## SIL MT102-01 Service Information Letter for MT102 Magnetic Transducer Accessory

Date: March 13, 2014  
Regarding: MT102 Cable  
SIL Revision: A

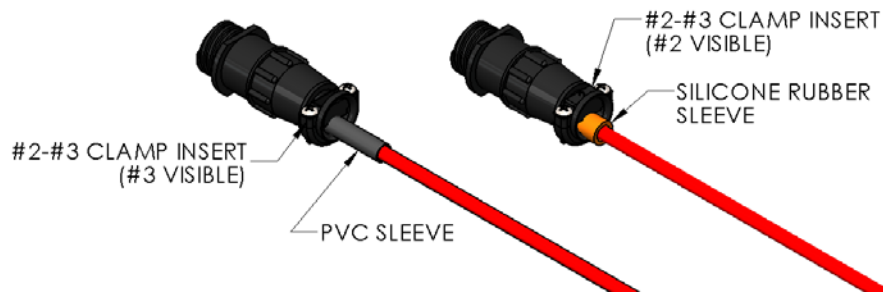
This Service Information Letter is applicable to MT102 units that do not have a sleeve on the cable installed by Sandel as shown in the following image.

Without the presence of a cable sleeve on the MT102 cable, there may be excessive clamping force on the cable resulting in shorting of the individual wires in the cable bundle. To alleviate this potential issue, the cable clamp force may be reduced by loosening the two screws on the clamp.

Back the screws out until they are loose and then retighten them until the clamp contacts the cable while not exerting excessive force. The screws should just be snug. The distance between the connector housing and the cable clamp should be approximately 0.125" as shown in the following image.
